Nomination Form
Anadromous Waters Catalog

Name of Water Body Kiwalik River & Mud Creek Channel

Nomination # 24-659

Map #1

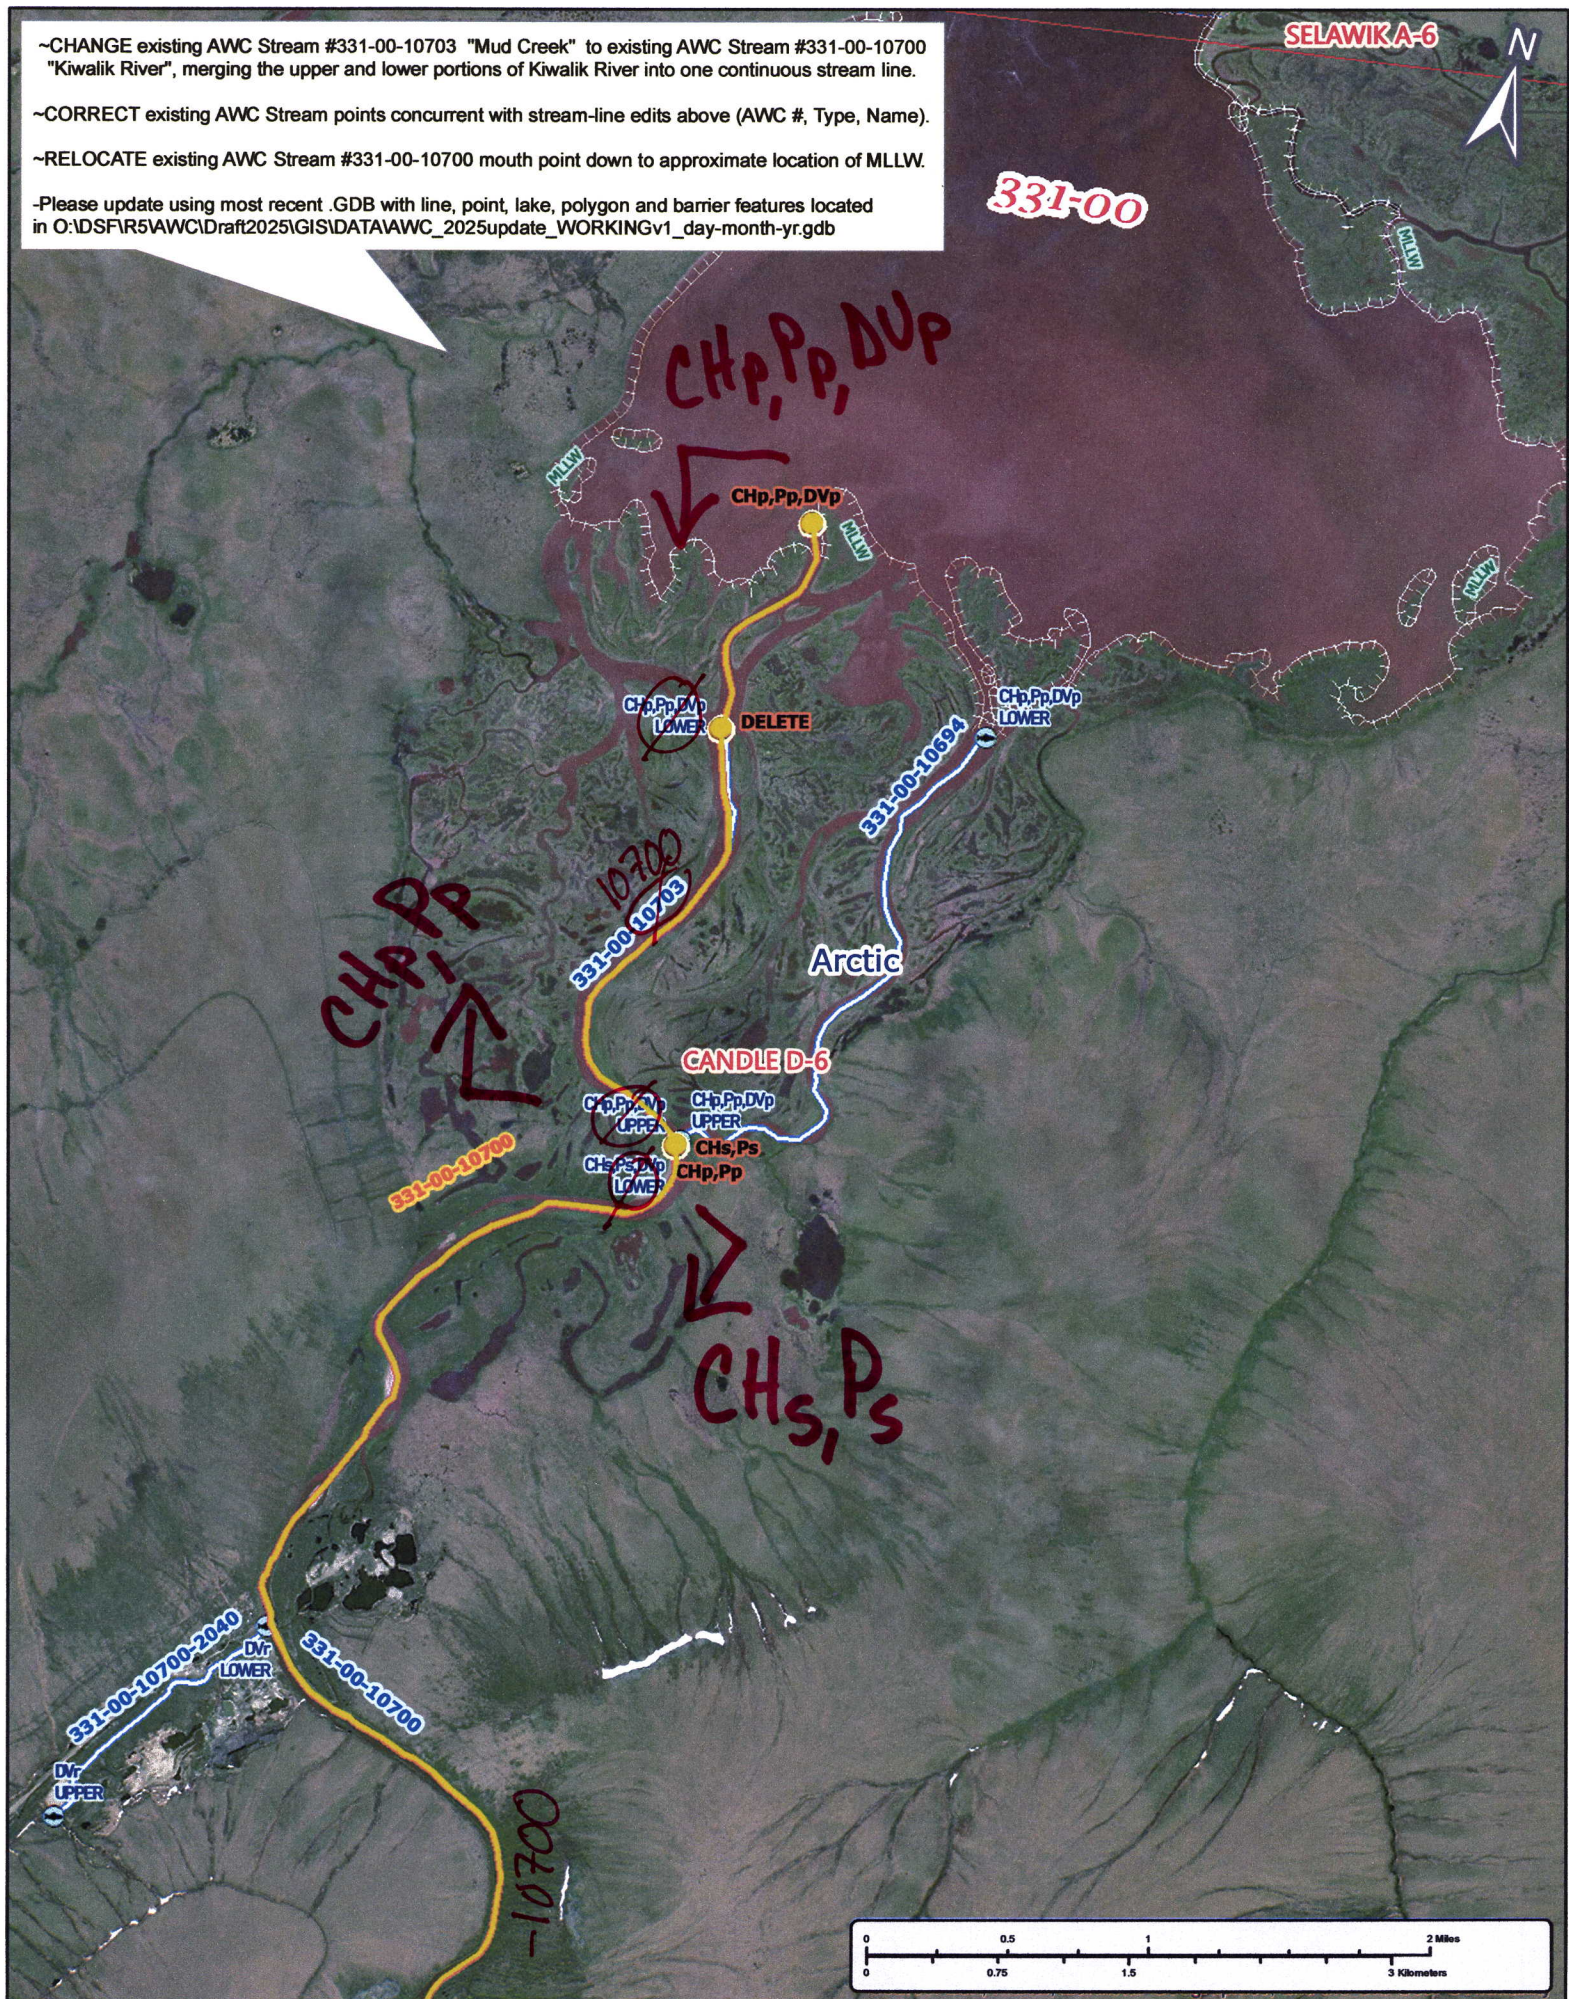
~CHANGE existing AWC Stream #331-00-10703 "Mud Creek" to existing AWC Stream #331-00-10700 "Kiwalik River", merging the upper and lower portions of Kiwalik River into one continuous stream line.

~CORRECT existing AWC Stream points concurrent with stream-line edits above (AWC #, Type, Name).

~RELOCATE existing AWC Stream #331-00-10700 mouth point down to approximate location of MLLW.
